LUSCOMBE AIRPLANE CORPORATION  
West Trenton, New Jersey

ENGINEERING BULLETIN #11

January 11, 1940

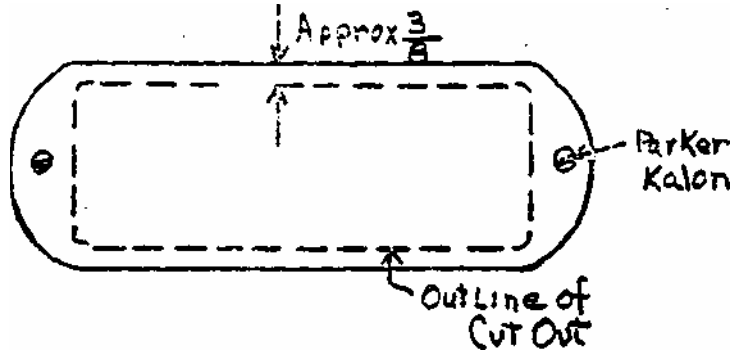
For cold weather operation, it may be found that the engine will not maintain a satisfactorily high oil temperature. This condition may be corrected by closing the center cooling port in the cowling. It is recommended that this be done as per sketch above, using approximately .032 aluminum or aluminum alloy for the cover plate.
